STAFF RECOMMENDATION

1104 Petway Avenue

March 17, 2021

Description of Project: Application for the construction of a rear addition that is two feet (2') taller than the historic house.

Figure 4. Right side elevation

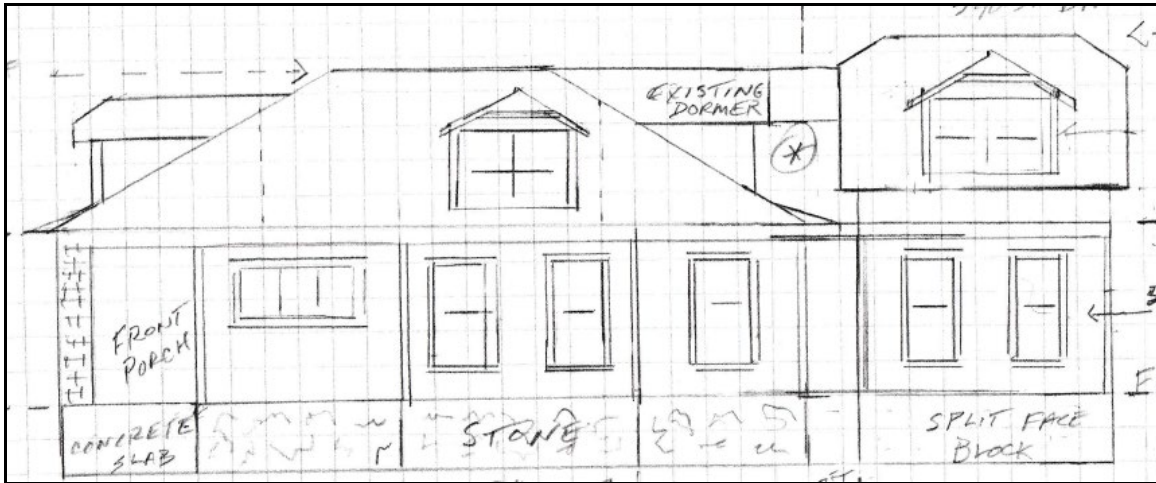
Height & Scale: The historic house is nineteen feet (19') tall from finished floor. The ridge of the proposed addition will be twenty-one feet (21') from finished floor. The guidelines allowed for additions that go up to four feet (4') taller and specify that the increased height should be set forty feet (40') back from the front of the historic house. The higher portion in this case starts forty-two feet (42') from the front wall of the house, and steps only two feet (2') taller. Staff finds this to meet the guidelines. (Figure 4) The foundation height of the addition will be consistent with the foundation height of the historic house. The eave height will be about two feet (2') taller than the historic eave.

Staff finds that this could be appropriate in this instance, as the square footage of the addition is very modest at about five-hundred and forty (540) square feet.

The addition steps in one foot on both sides for a depth of three feet (3') before the walls step back out flush with the historic side walls. On the upper level, the existing dormer will extend to connect to the addition. The face of the new dormers will be inset two feet (2') from the face of the historic dormers and from the wall below.

Staff finds that the project meets Section II.B.1. a and b for height and scale.

PLOT PLAN
FOR
ALAN B. MINCHEW

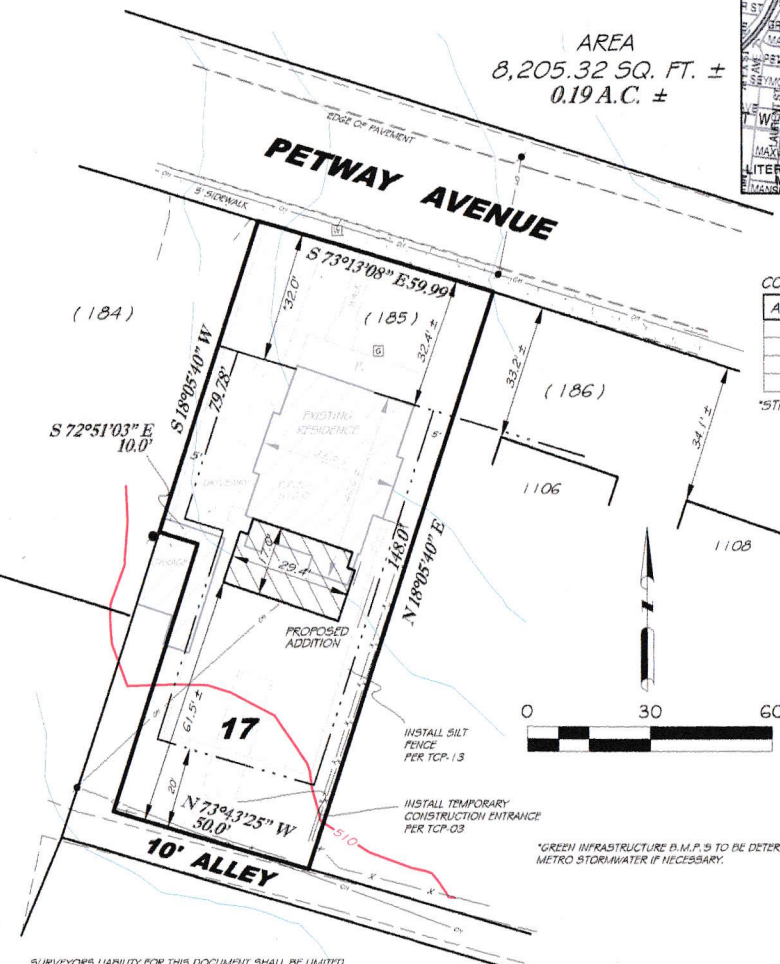
Setback & Rhythm of Spacing: The addition will not impact the front or side setbacks. The rear of the addition will be more than sixty feet (60') from the rear property line.

Appurtenances & Utilities: No changes to the site’s appurtenances were indicated on the drawings. The location of the HVAC and other utilities was also not noted. Staff asks that the HVAC be located behind the house or on either side, beyond the midpoint of the house, and utility meters be located on the side of the building, within 5’ of the front corner or on the rear or rear-side within 5’ of the rear corner. Alternative mechanical and utility locations must be approved prior to an administrative sign-off on building permit(s). The project meets section II.B.1. i.

1. Staff approve the final roof color, rear stair material, windows and doors prior to purchase and installation; and,
2. The HVAC shall be located behind the house or on either side, beyond the mid-point of the house, and utility meters shall be located on the side of the building, within 5’ of the front corner. Alternative mechanical and utility locations must be approved prior to an administrative sign-off on building permit(s);

VIEW FROM BACK YARD

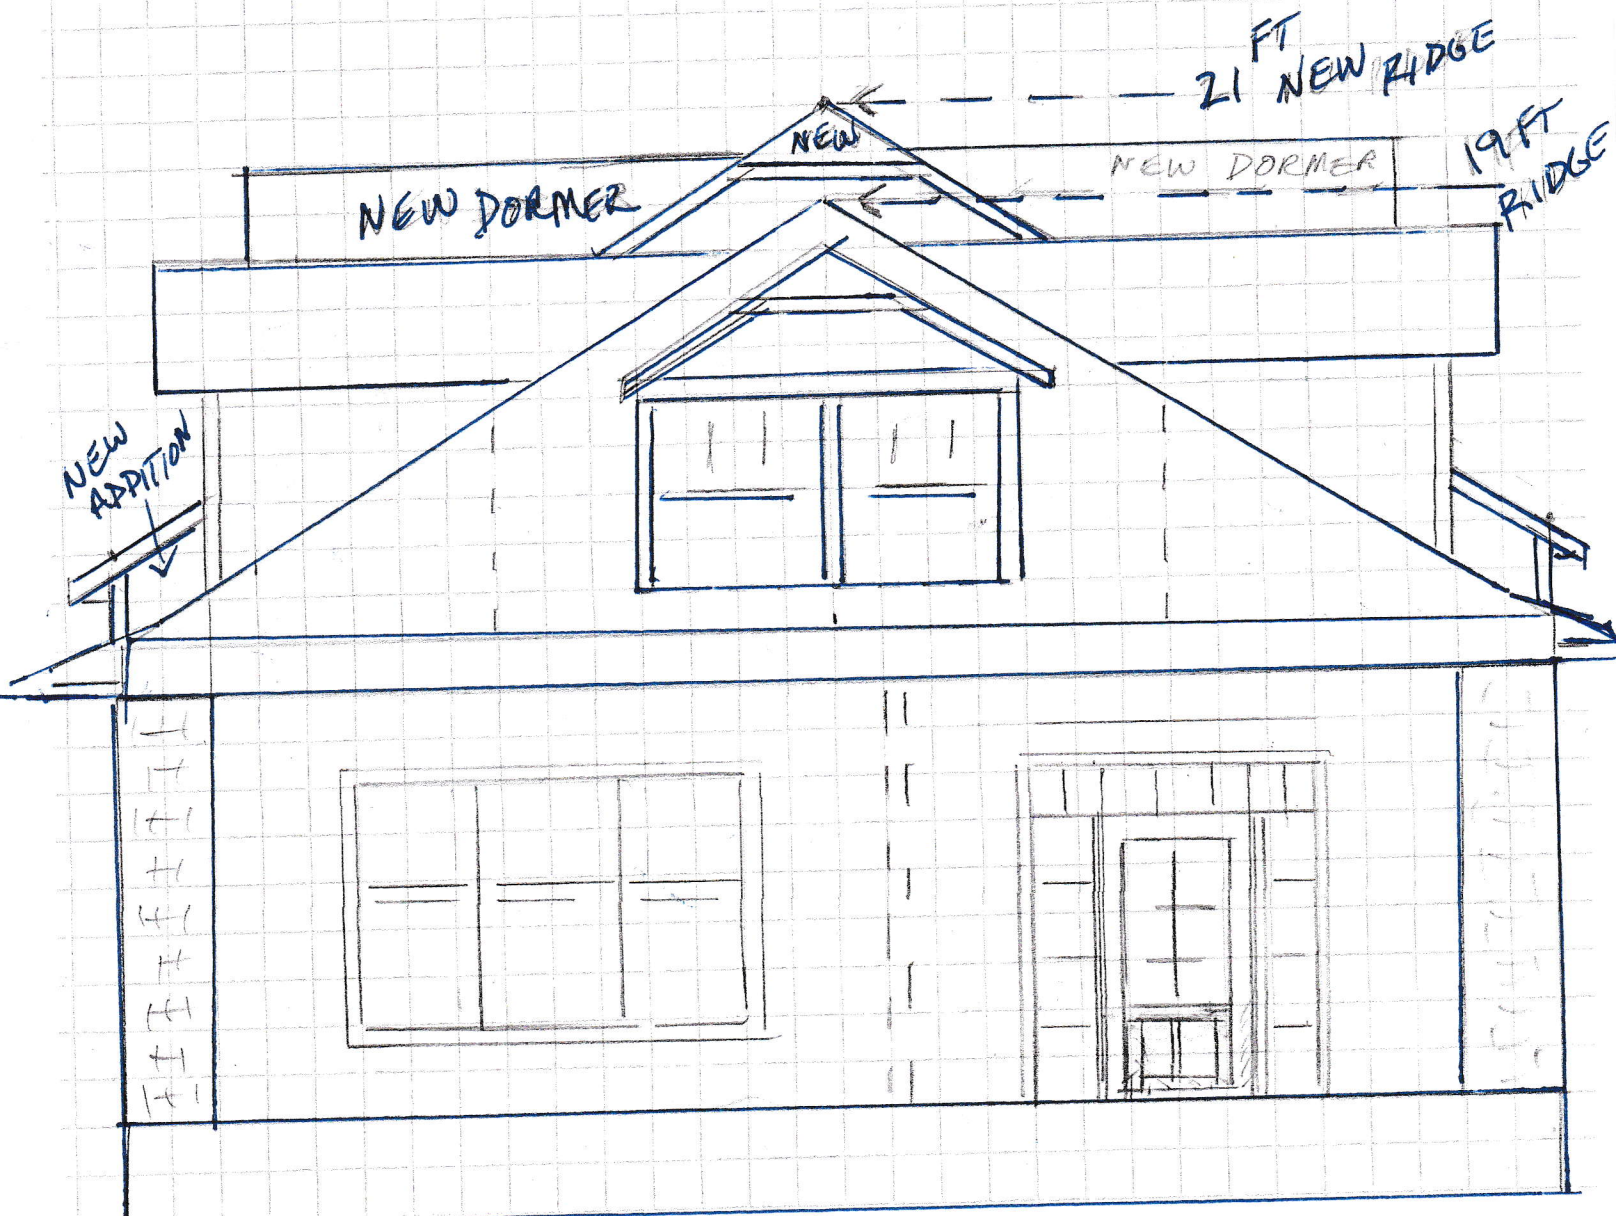
A door is indicated on the rear elevation several feet above ground level. (Figure 6) A stair will need to be provided here. With final staff approval of the roofing color, rear stair material, windows and door, staff finds that the project meets section II.B.1.d

Roof form: The addition uses a rear-facing gable with a gabled dormer on each side elevation. The main roof form is clipped, which is consistent with the guidelines' specifications for the roofs of additions that are taller than the historic building. The slope matches that of the historic house at about 7/12. The dormers are inset two feet (2') from the side wall below and also about two feet (2') from the historic dormers. (Figure 6)

Shorter windows are found in the dormers, which is appropriate, and there is one pair of shorter, more squared windows on the rear elevation, which staff finds to be appropriate in that location. Paired windows should have a four to six inch (4”-6”) mullion in between. There are no large expanses of wall space without a window or door opening. Staff finds the project’s proportion and rhythm of openings to meet Section II.B.1.g.
